**MINUTES**  
**BOARD OF BUILDING STANDARDS/  
ARCHITECTURAL BOARD OF REVIEW/SIGN REVIEW**  
**REVIEW MEETING**  
**CITY OF LAKEWOOD**  
**12650 DETROIT AVENUE**  
**AUDITORIUM**  
**DECEMBER 8, 2022**  
**5:30 P.M.**  
**RECORDED**  
<https://www.lakewoodoh.gov/videos-2/>

**SIGN REVIEW**

**ARCHITECTURAL BOARD OF REVIEW**

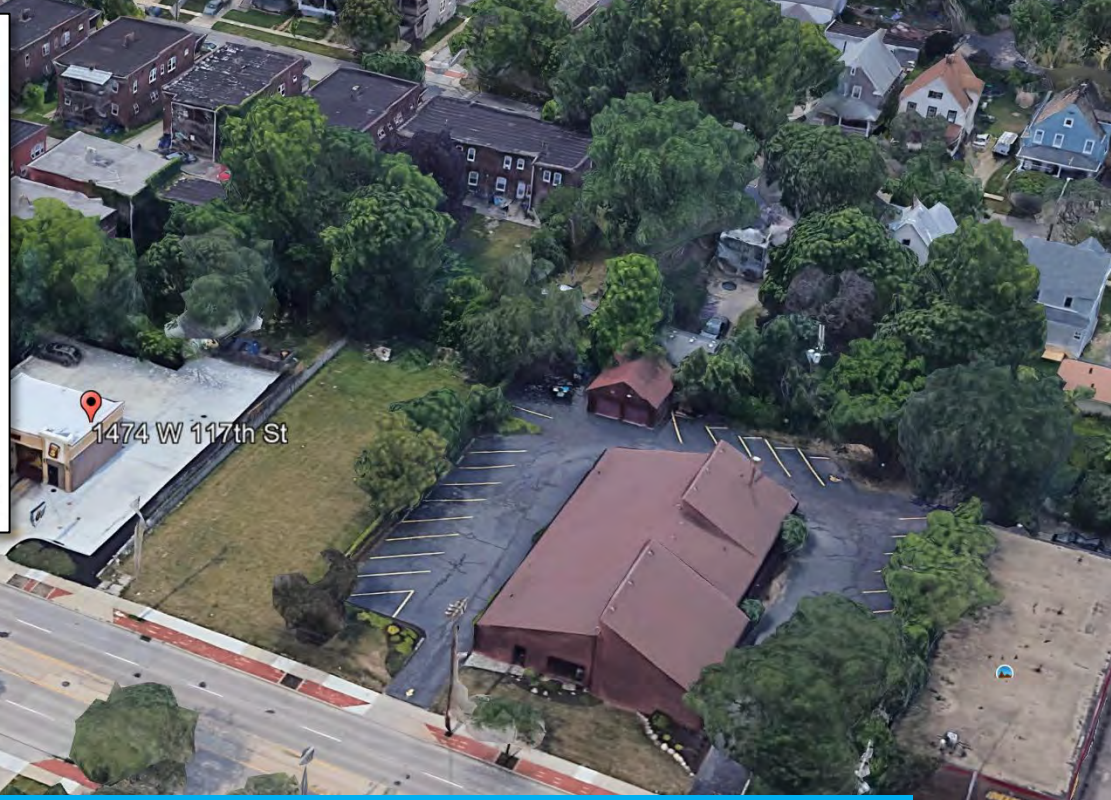
- Given proposed white background, **provide internal opaque shielding** to restrict nighttime illumination to just the logo and lettering – avoiding excess glare per Section 1329.06 (a): “*Light sources to illuminate signs shall be shielded from all adjacent buildings and streets and shall not be of such brightness so as to cause glare hazardous to pedestrians or motorists...*”

**1** RAILING ELEVATION  
SCALE: 1/2"=1'-0"

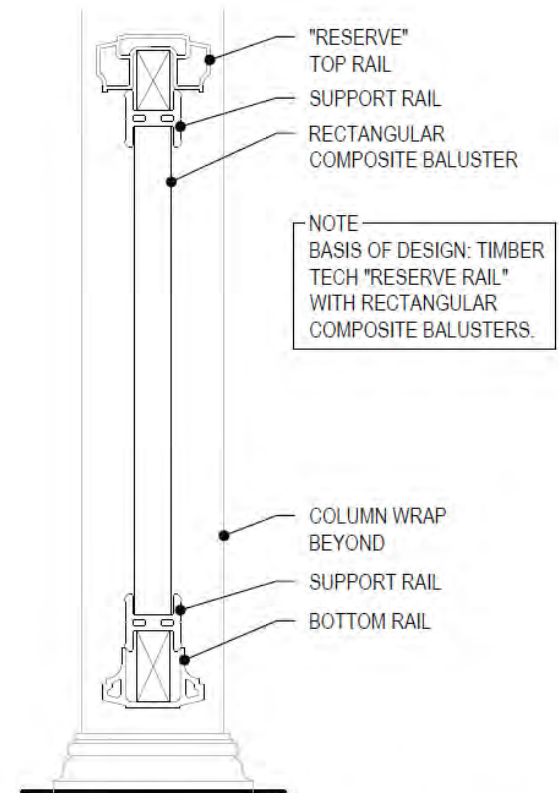
- **The railing detail will be as presented (not the railing elevation as in the packet).**
